CHANGE/ERRATA INFORMATION

ISSUE NO: 3            7/85

Title:            732A  
Print Date:      May 1983  
Rev.- Date:      ---

Figure 1.

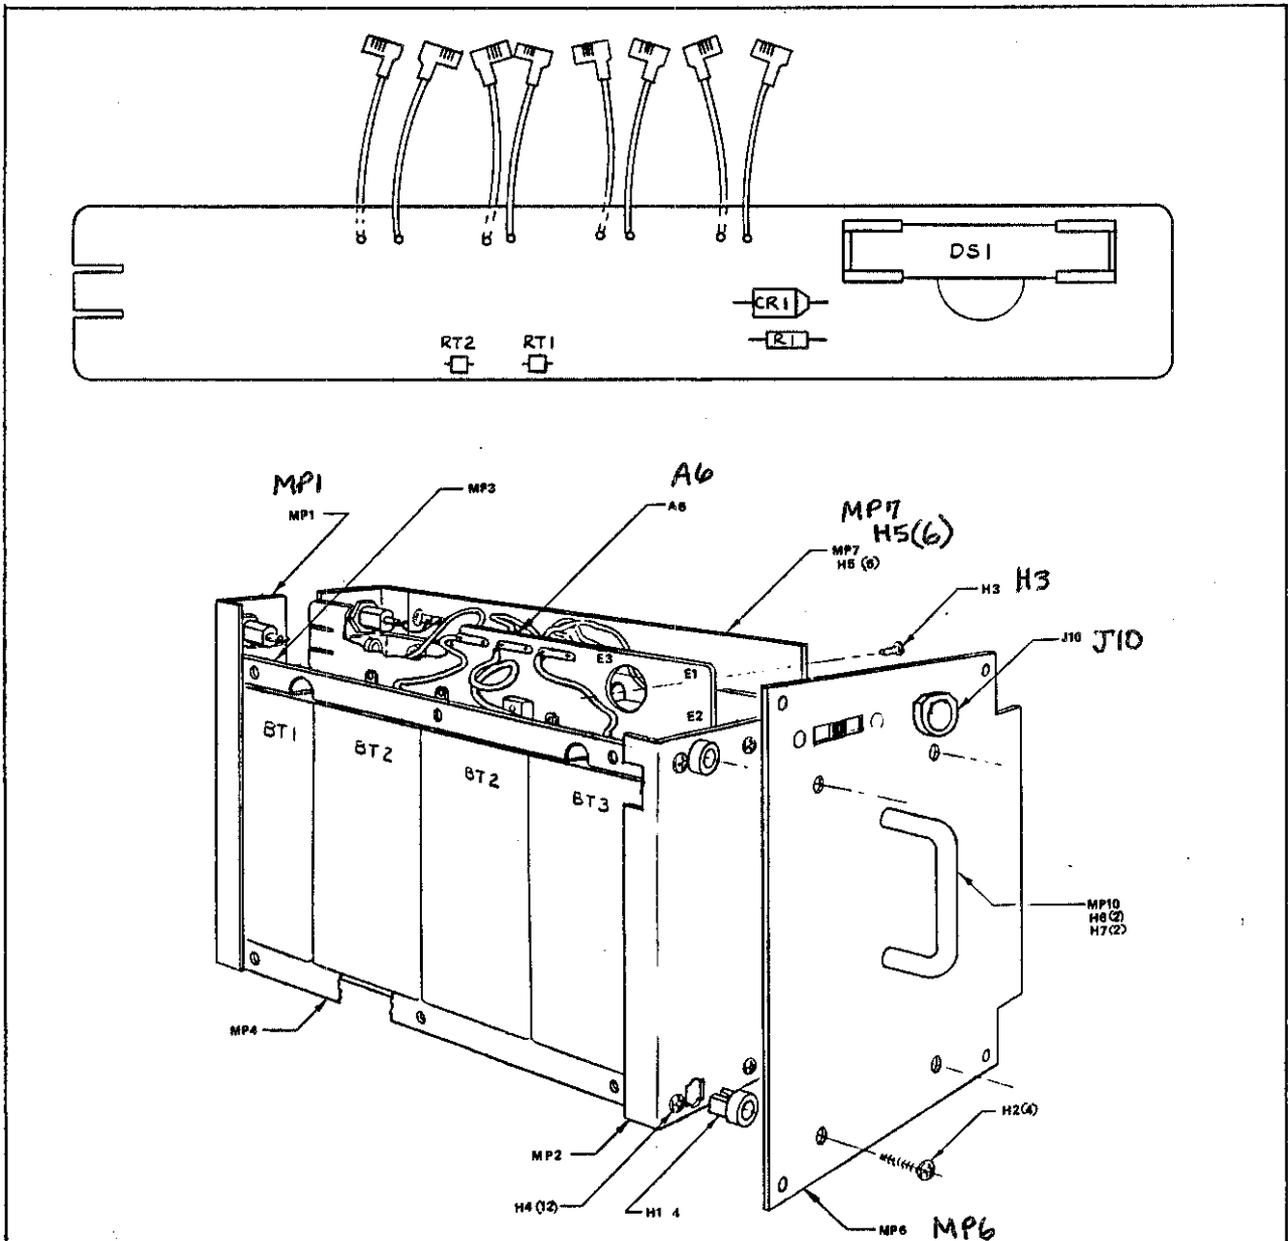
The following change documents the change over from the integral output lead batteries to the spade lug batteries.

On page 5-23, Figure 5-7, replace the entire figure with Figure 1.

On page 8-4, Figure 8-2, replace the A6 Battery Module portion of the figure (732A-1604), with the top portion of Figure 1.

Figure 2.

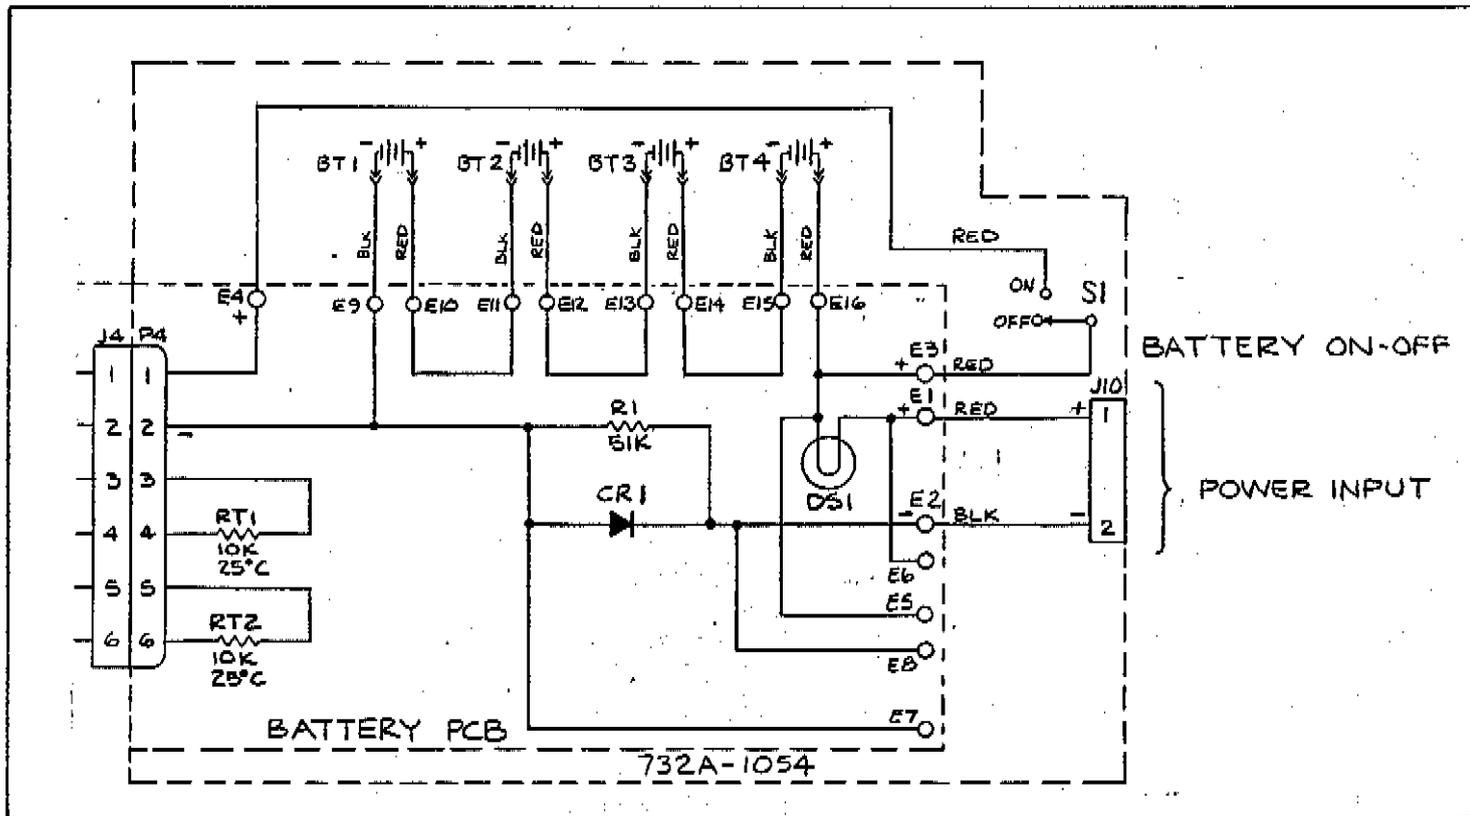
On page 8-5, Figure 8-2, delete J1, J2, J3 and J4 as shown in Figure 2.

Figure 3.

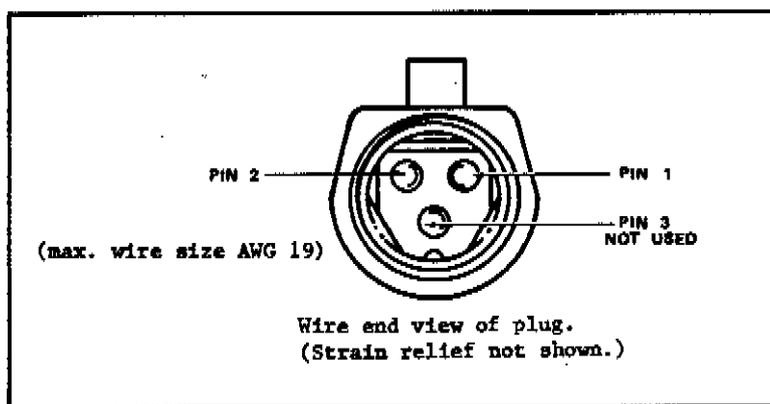
2. Push the contact header out of the plug housing in the direction of the strain relief.
3. Solder a contact onto each wire using awg 19 to 22 gage wire or 2 conductor cable with an outside diameter smaller than .216 inches. (See Figure 2-1a.)
4. Install the strain relief nut and the strain relief onto the cable in correct order and orientation.
5. Insert one soldered contact into the contact header hole no.1 (+) and the other into hole no.2 (-).
6. Reassemble the plug.

On page 2-2, add Figure 2-1a. as shown in Figure 3.

Figure 4.

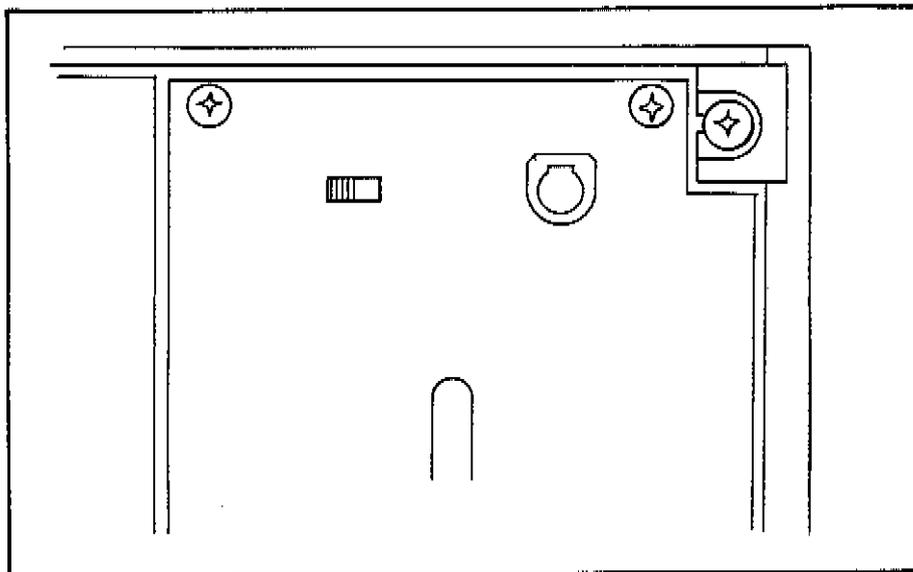
On page 2-3, Figure 2-2, replace item 6 (dual power input banana jacks) with a single external power input connector as shown in Figure 4.

Figure 5.

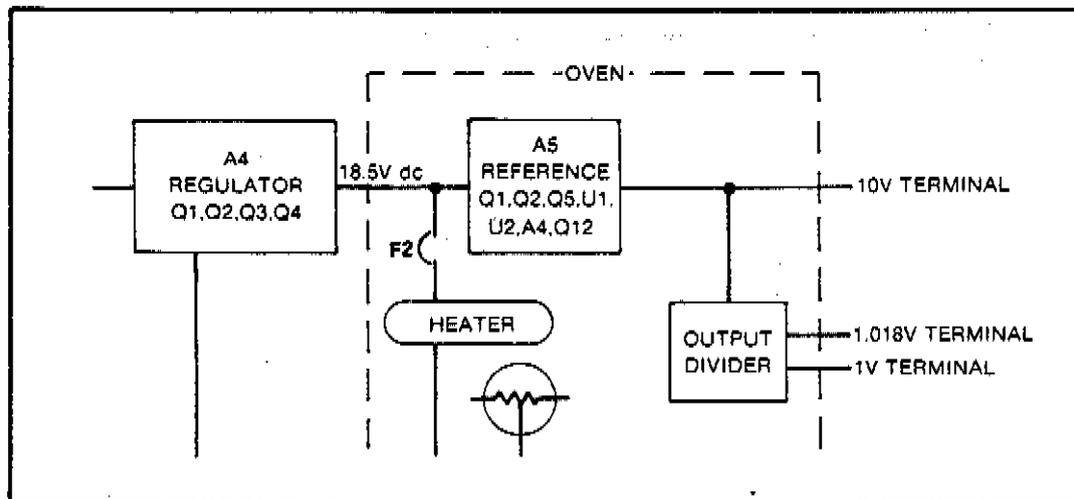
3-30. Protection against overtemperature is provided by a 58 C thermal fuse (F2) which is placed directly on top of the ovenized reference module. When F2 opens, it interrupts the +18.6V supply connection to the oven heater. It also disconnects the +18.6V from the latch circuit Q6 on the Regulator PCB causing the IN CAL LED to go out and stay out until the fault is corrected.

On page 3-3/3-4, Figure 3-1, add the thermal fuse (F2) as shown in Figure 5.

Figure 6.

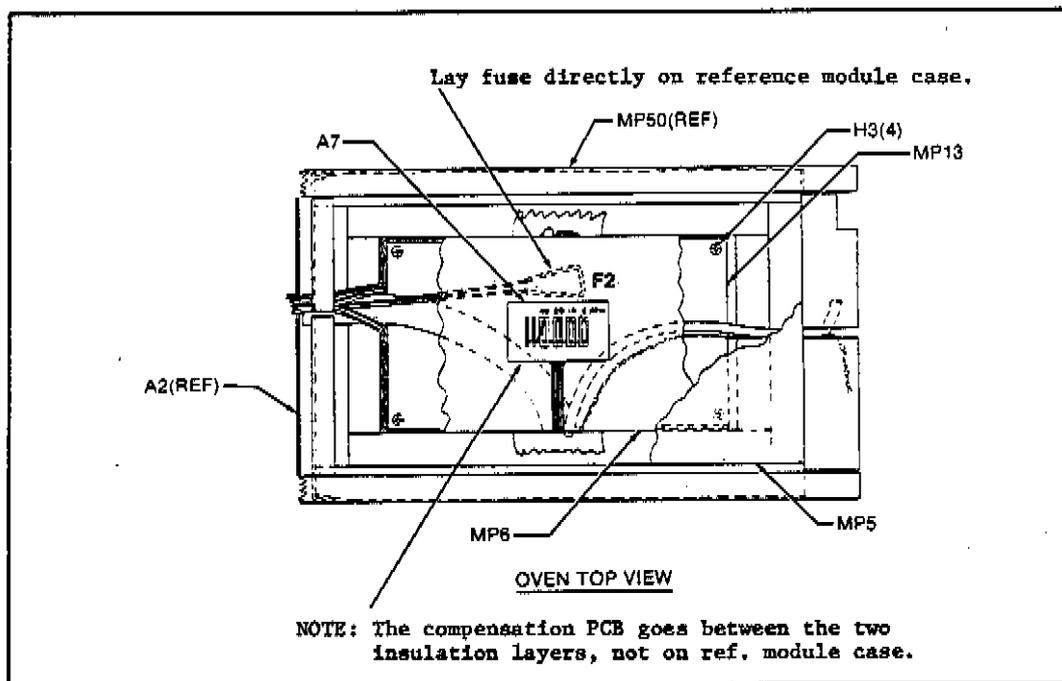
On page 5-8, Figure 5-1 add F2 to the OVEN TOP VIEW as shown in Figure 6.

Figure 7.

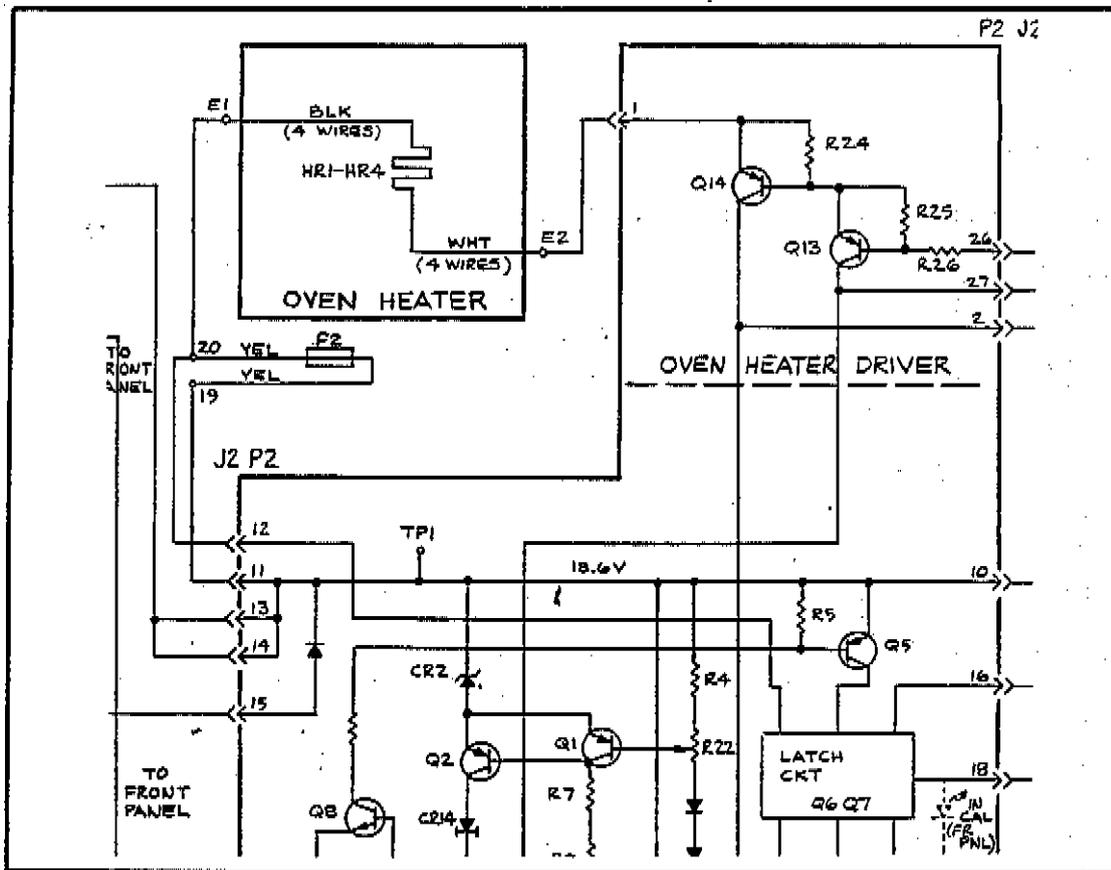
On page 8-3, Figure 8-1, change the schematic to include F2 as shown in Figure 7.

Figure 8.

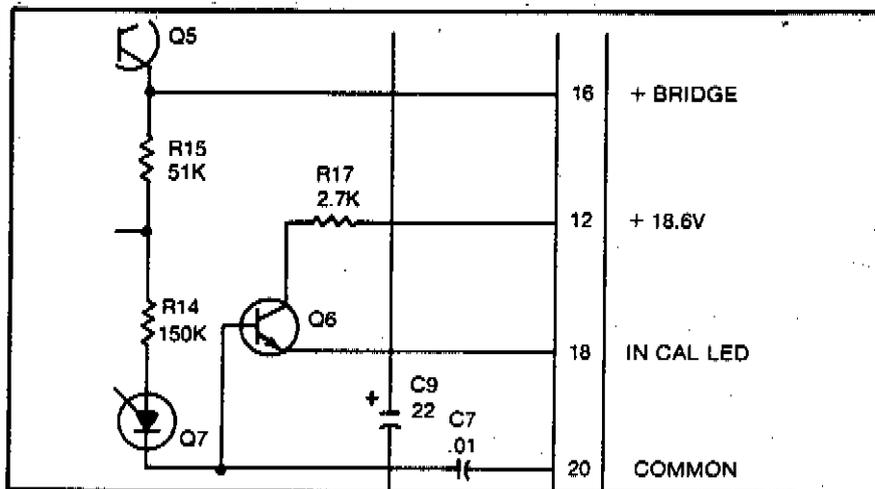
On page 8-9, Figure 8-4, change the schematic as shown in Figure 8.

Figure 9.

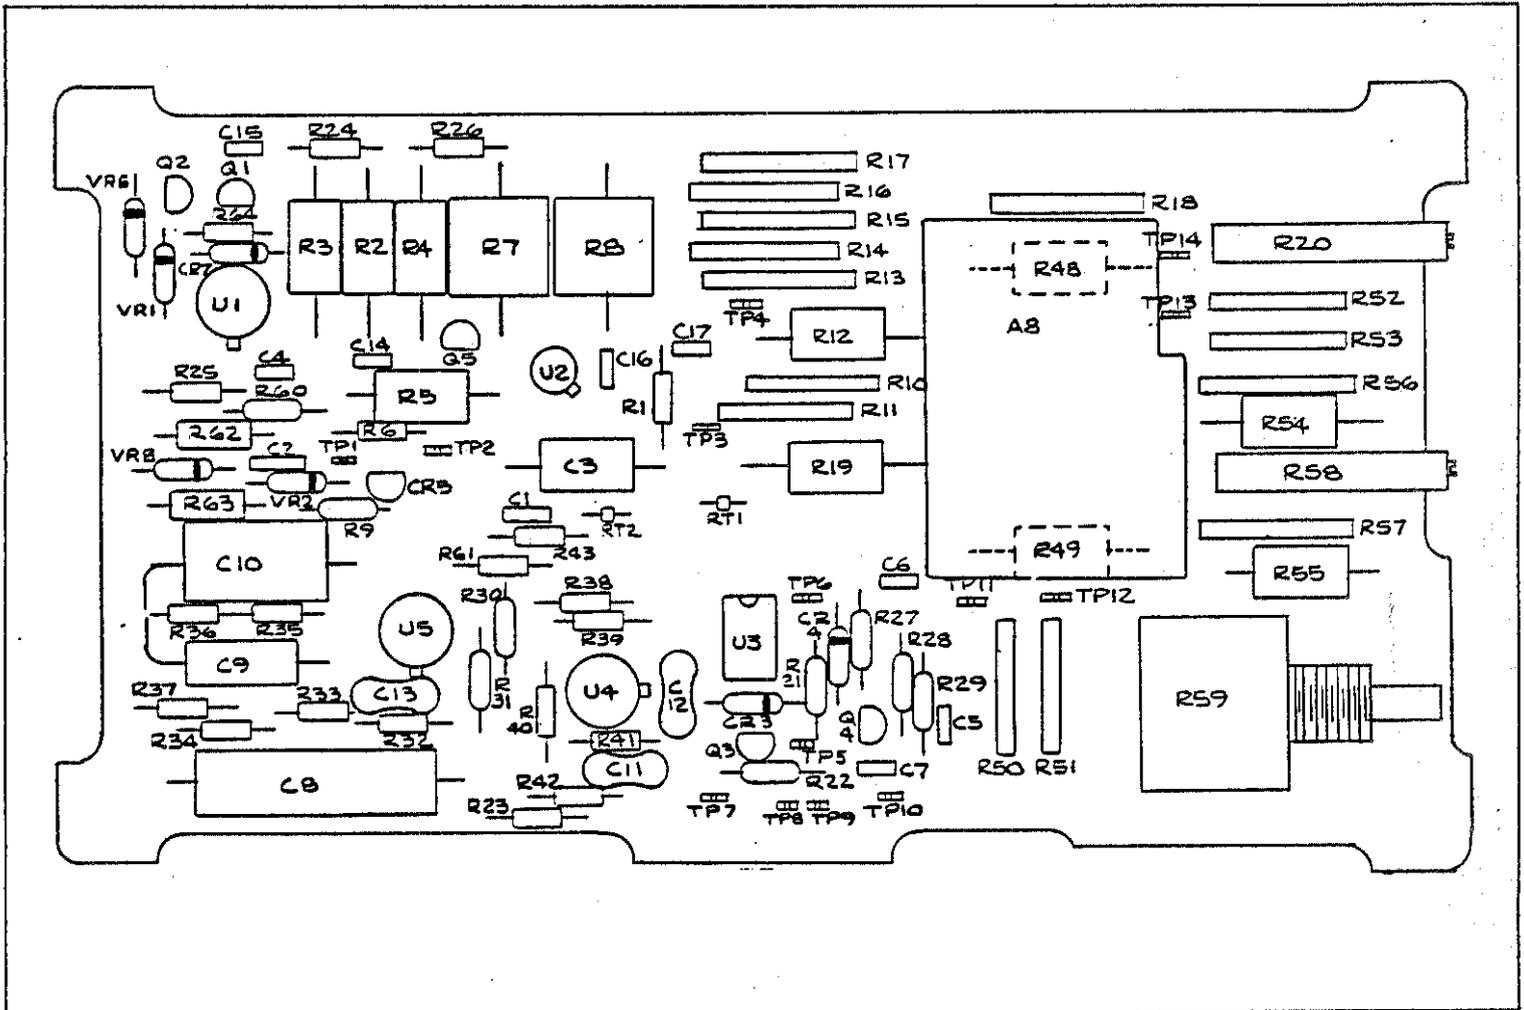
On pages 5-21 and 8-10, replace Figures 5-6 and 8-5 with Figure 9.

Figure 10.

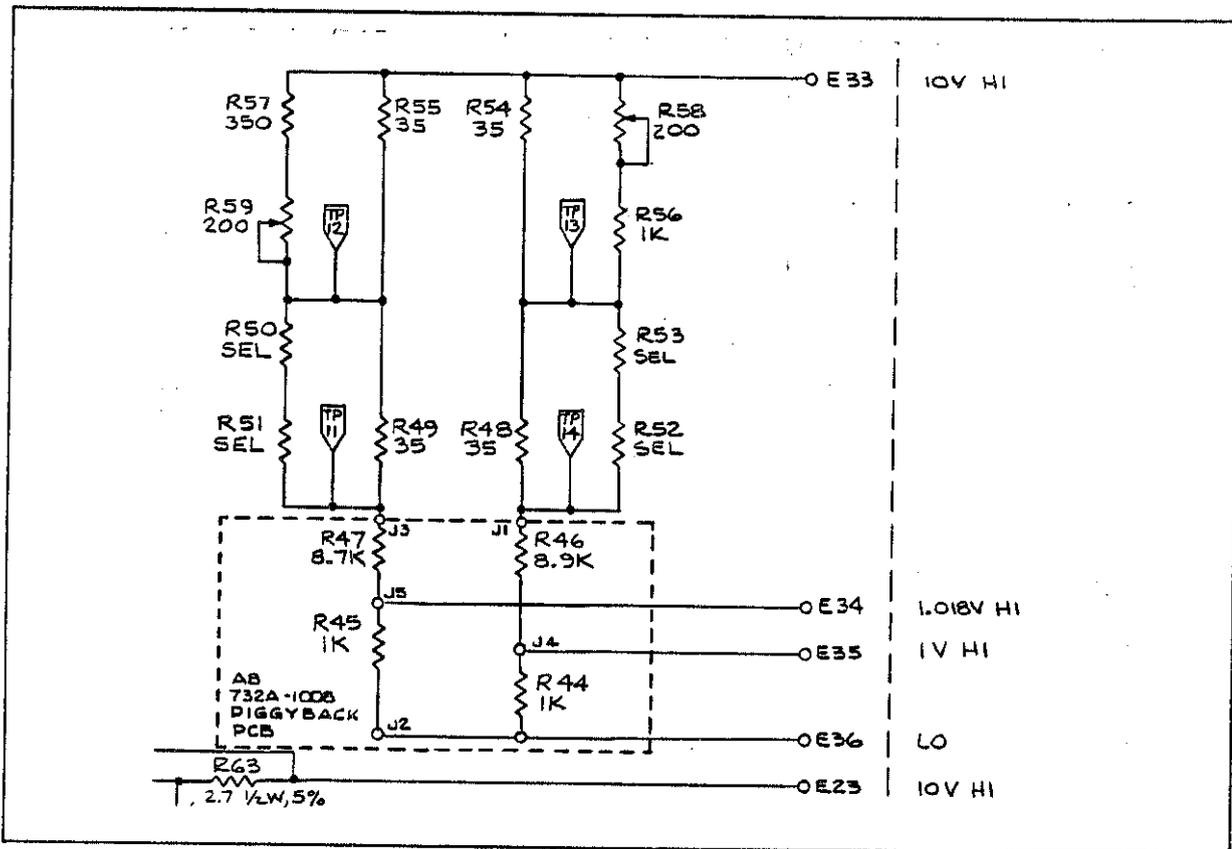
On page 8-11, change Figure 8-5, as shown in Figure 10, to show the addition of the A8 PCB to the A5 PCB.

Figure 11.

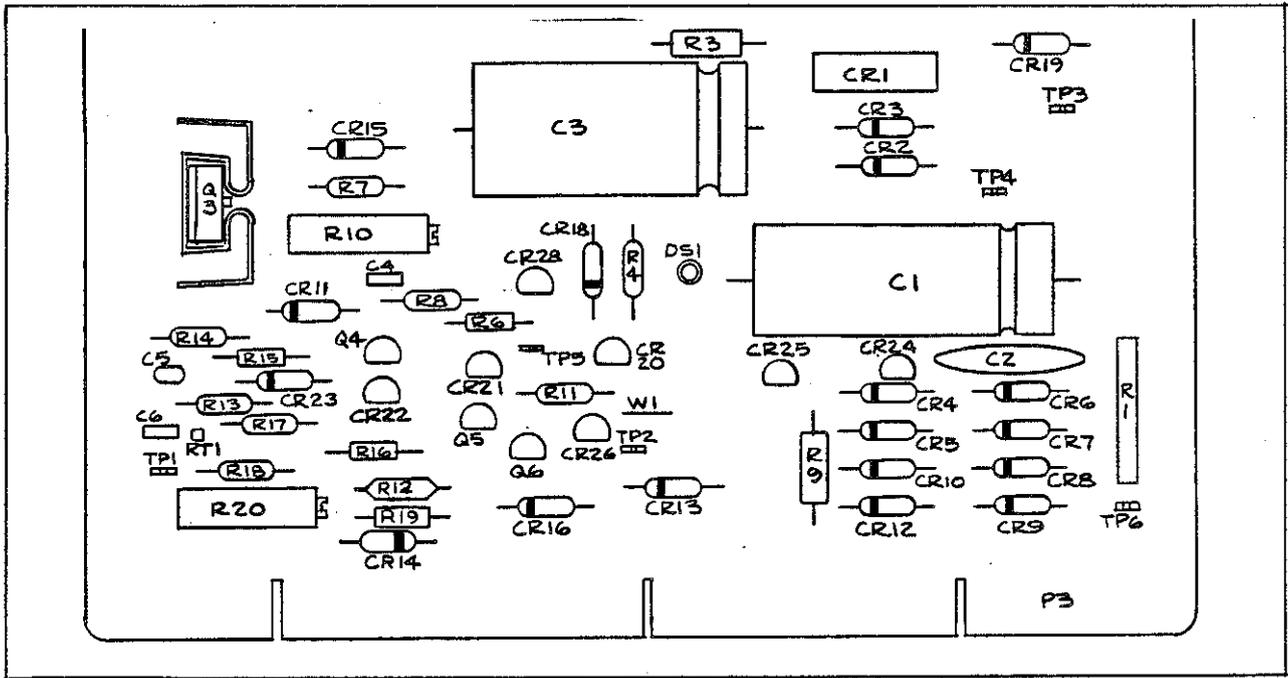
On pages 5-14 and 8-6, Figures 5-4 and 8-3, add R19 as shown in Figure 11.

Figure 12.

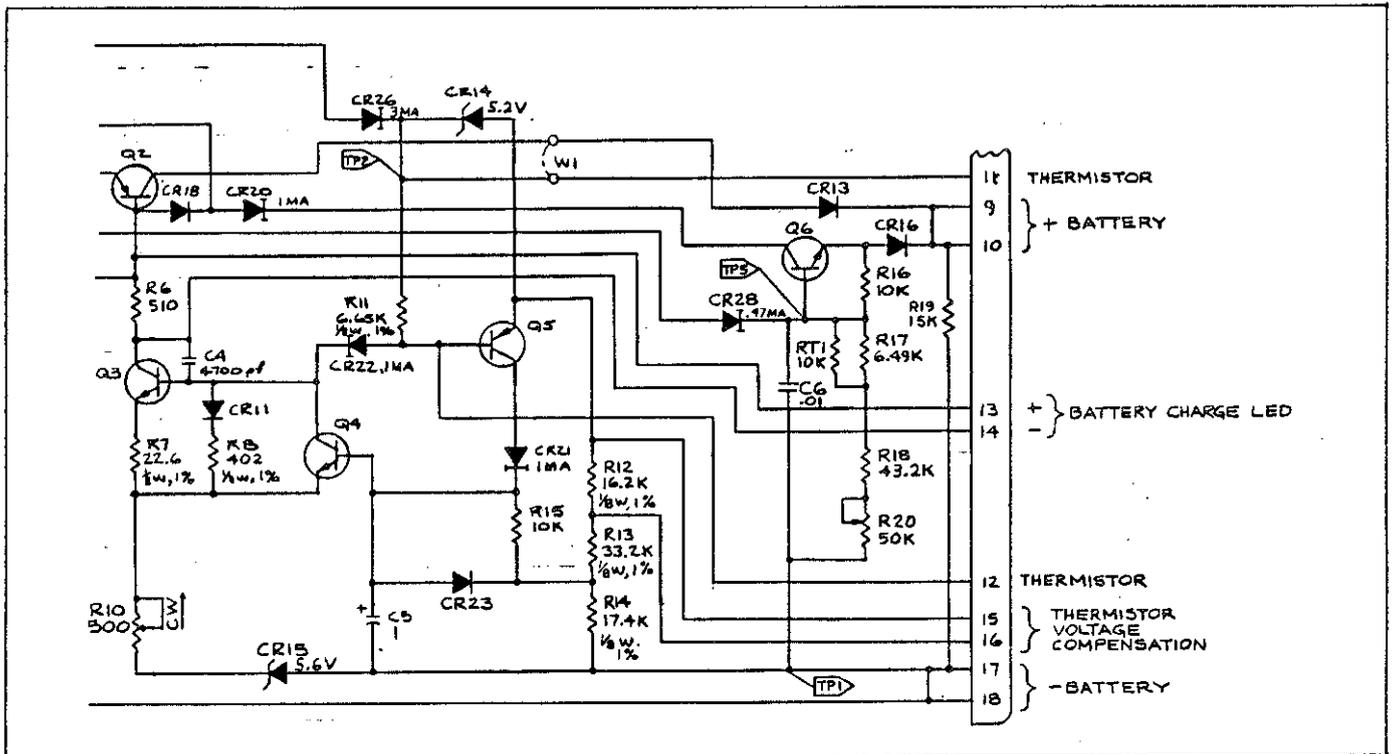
On page 8-7, Figure 8-3, change the value for R8 from 402K to 402, and add R19 as shown in Figure 12.
